# HARDEN ADDITION

Re: S/D 96-53 HARDEN ADDITION (Final Plat)

**CASE NUMBER:** S/D 96-53 HARDEN ADDITION

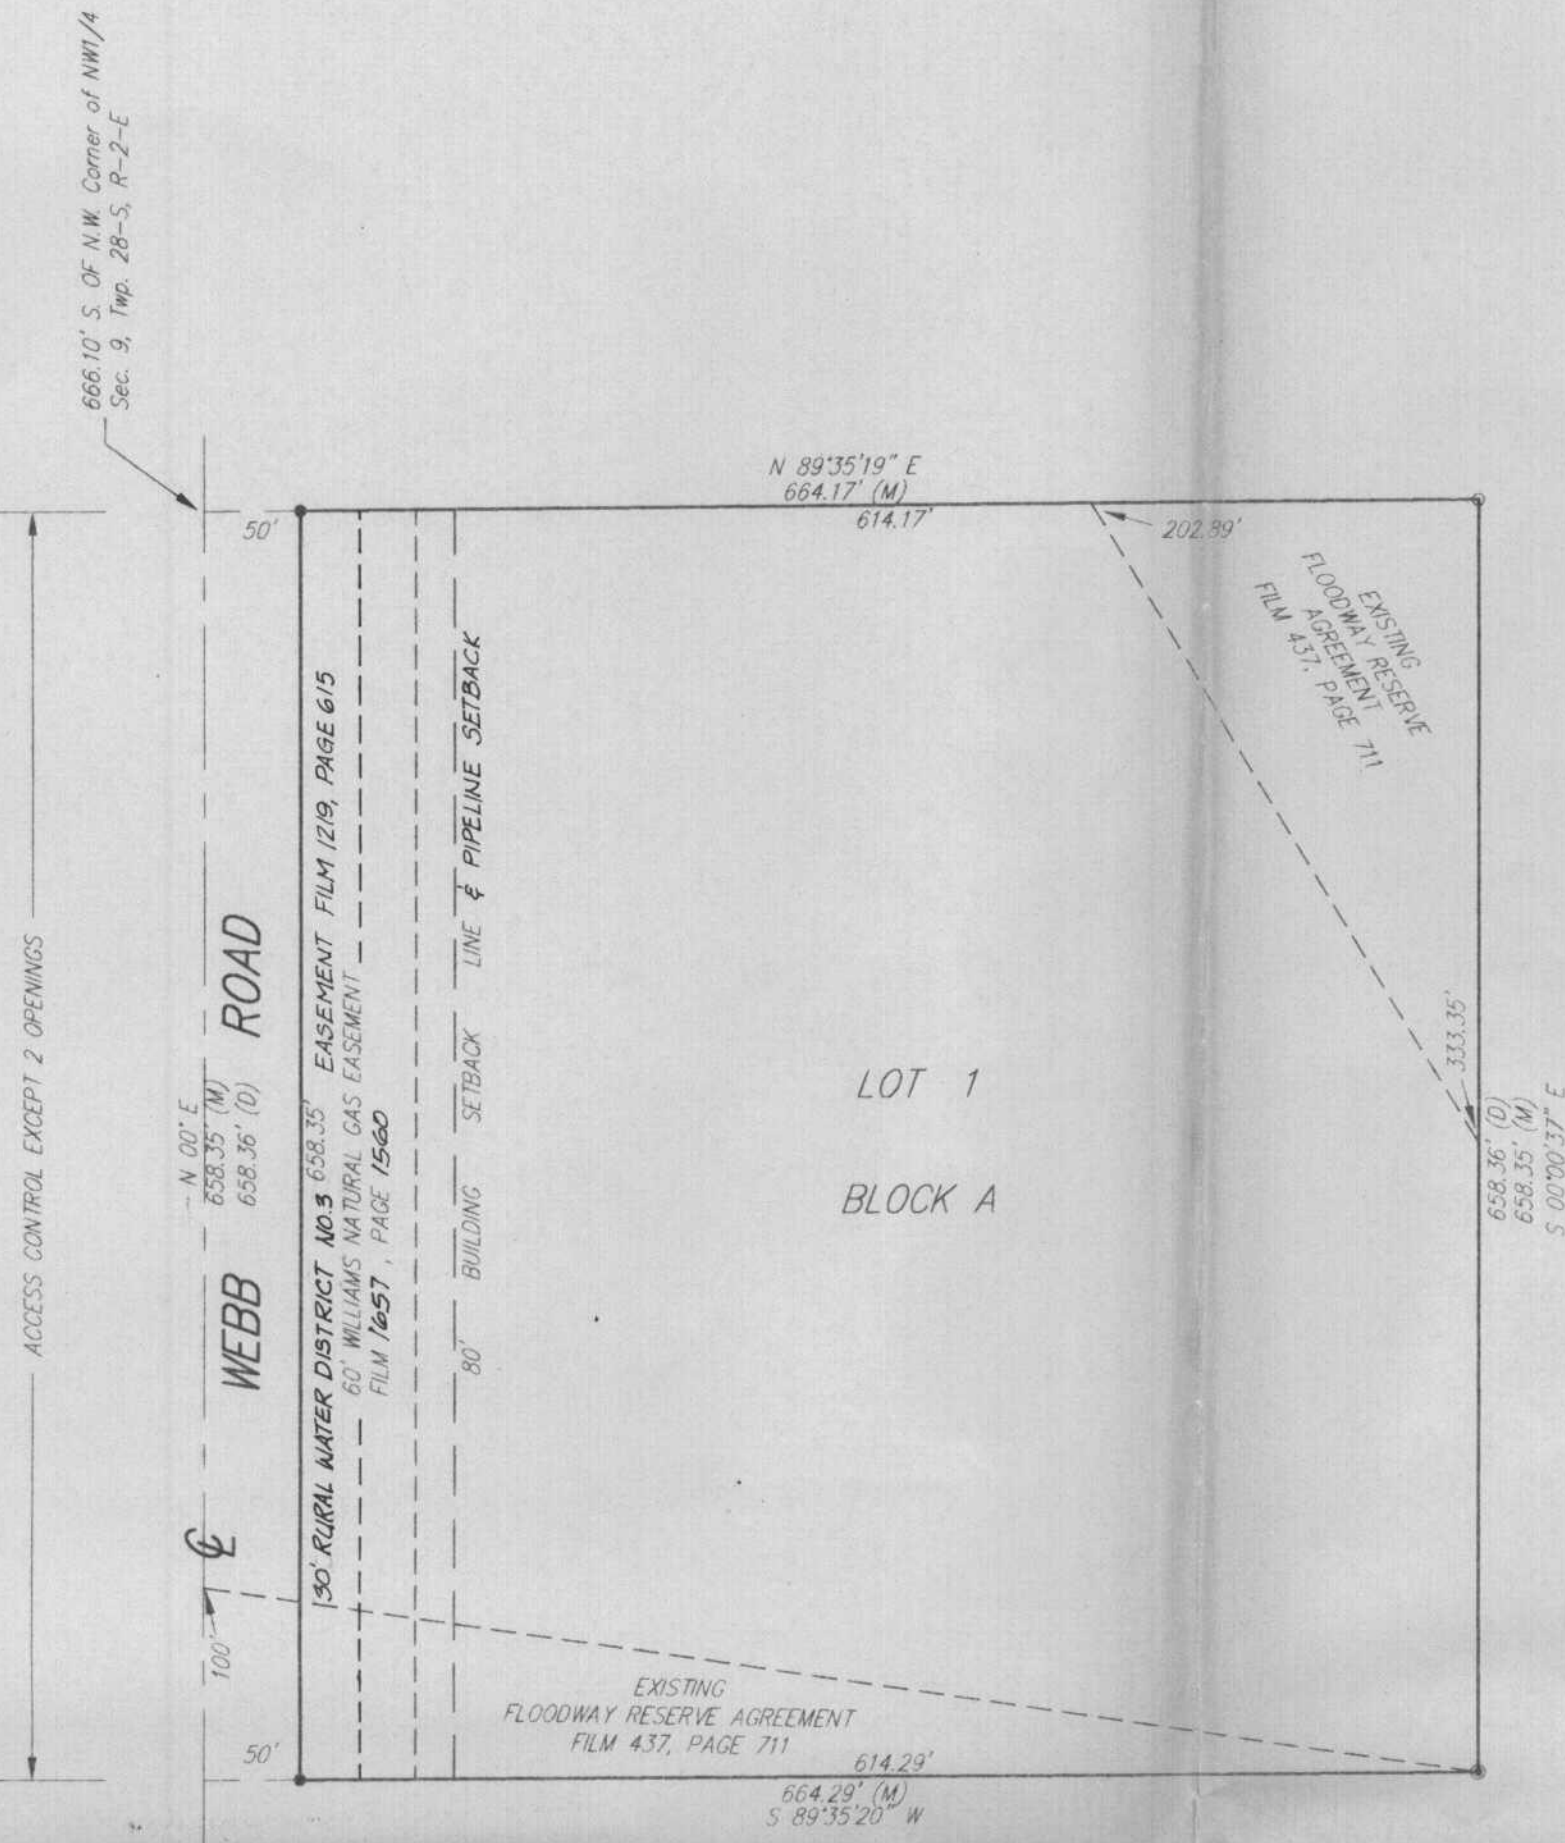
- B. The applicant shall guarantee any drainage improvements required by the platting of this property.
- See 1st plat submitted by agent*  
C. At this time, the plat is encumbered by a blanket pipeline easement. The 50-foot easement as now shown is the area to which it is expected that the easement will be confined to. Prior to this plat being scheduled for City Council review, this pipeline shall have been confined as is being noted. The final plat tracing shall, therefore, properly reflect the easement as confined. A copy of the recorded document creating this easement and therefore releasing the blanket easement shall be submitted to Planning. The final plat tracing shall also indicate the easement's recording information and the name of the involved pipeline company.

- D. Any relocation, lowering or encasement of the pipeline, made necessary by this development, will not be at the expense of the County.
- E. The platting binder notes that a rural water district easement is located along the west line of this site. It is not clear, however, if this easement is located on the plat itself or is in street right-of-way. If this easement is on the site itself, in whole or part, the final plat

tracing shall depict the easement and properly label the easement and show the recording information.

- ~~F.~~ On the final plat tracing, the street adjacent to this site shall indicate only the name of Webb Road.
- ~~G.~~ In order to retain a platted setback to Webb Road in the event the pipeline and easement were ever removed, the indicated 80-foot building setback shall be labeled as a "platted and pipeline" building setback.
- ~~H.~~ *OK current to Res. 2111111111*  
Since a floodway apparently impacts this site, the plat's text shall reference the standard floodway language.
- ~~I.~~ Since a minimum building pad elevation (1362 MSL) is required, both the plat's text and the face of the plat shall note such an elevation.

Also, both on-site and off-site benchmarks shall be provided.

- ~~J.~~ On the final plat tracing, Deputy shall be deleted from the City Clerk's signature line.
- ~~K.~~ The applicant shall install or guarantee the installation of all utilities and facilities which are applicable and described in Article 8 of the MAPC Subdivision Regulations. (Water service and fire hydrants required by Article 8 for fire protection shall be as per the direction and approval of the Chief of the Fire Department.)

- ~~Q.~~ As requested by the utilities, the final plat tracing shall indicate a 10-foot utility easement

along the north line of the plat.
